The Commission has issued the enclosed Amendment No. 79 to Facility Operating License No. DPR-56 for the Peach Bottom Atomic Power Station, Unit No. 3. This amendment consists of changes to the Technical Specifications (TSs) in response to your applications dated September 30, 1980 and March 30, 1981, as supplemented April 24, June 30 and July 15, 1981.

PEACH BOTTOM ATOMIC POWER STATION, UNIT NO. 3

AMENDMENT TO FACILITY OPERATING LICENSE

Amendment No. 79
License No. DPR-56

FIGURE 3.5.1.J MAXIMUM AVERAGE PLANAR LINEAR HEAT GENERATION RATE
VERSUS PLANAR AVERAGE EXPOSURE

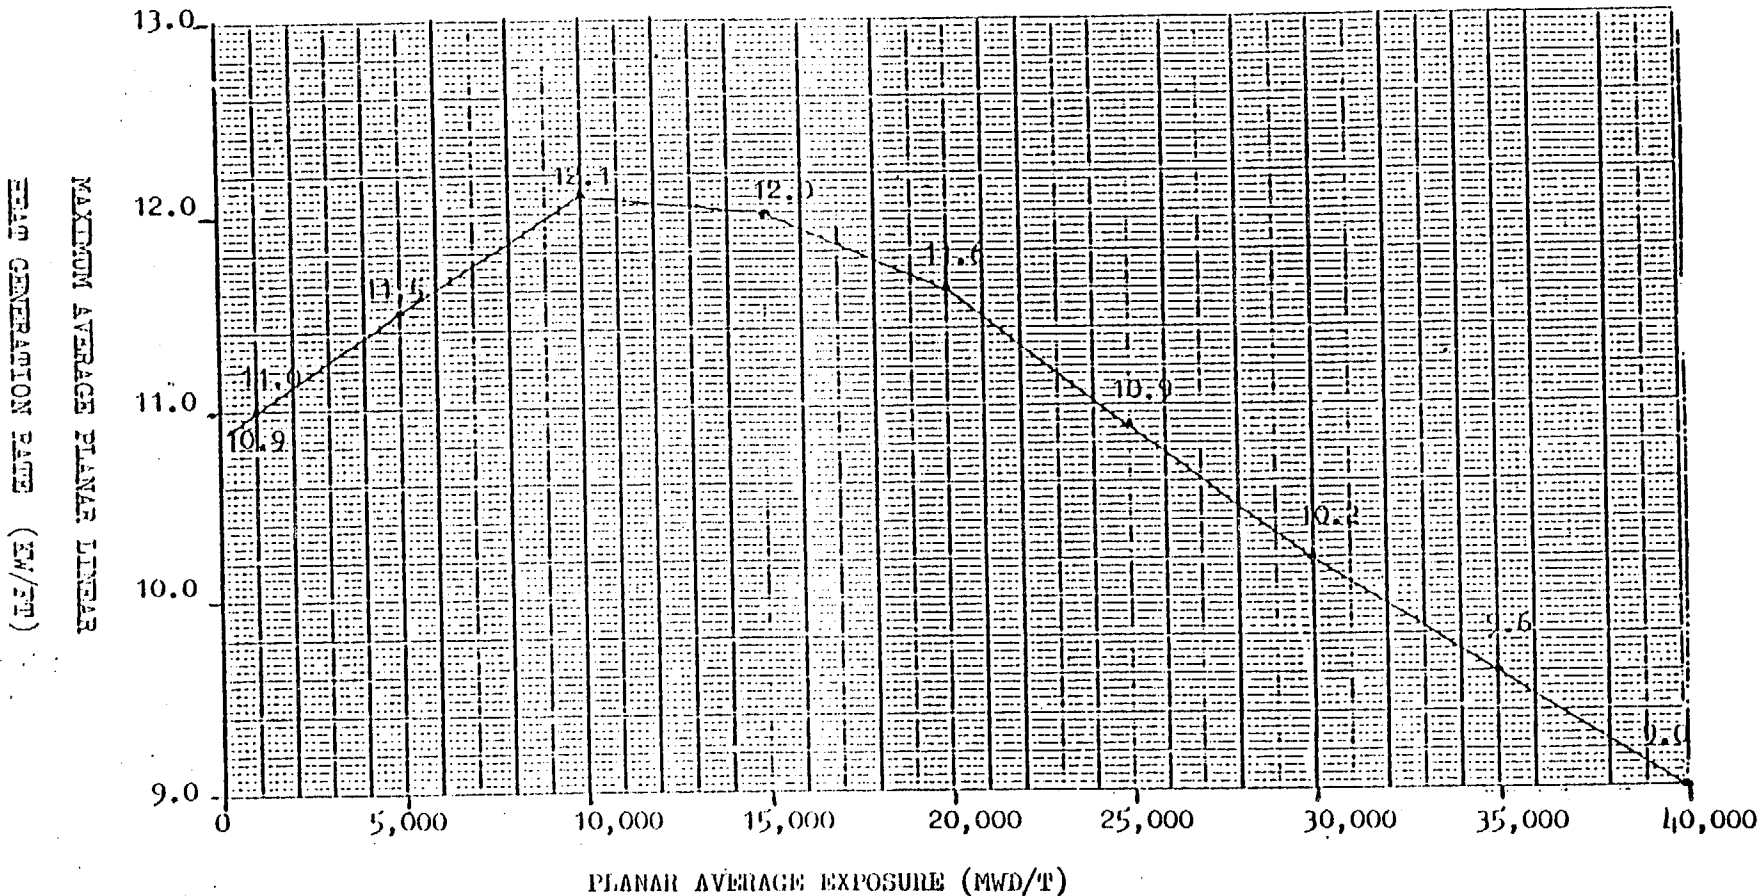
To ensure that the environmental considerations in 10 CFR 51 are evaluated, if MAPLHGR limits are extended in the future, we have, with the licensee's concurrence, added a note to the TS Figures related to MAPLHGR limits, stating the requirement of 10 CFR 51.20.
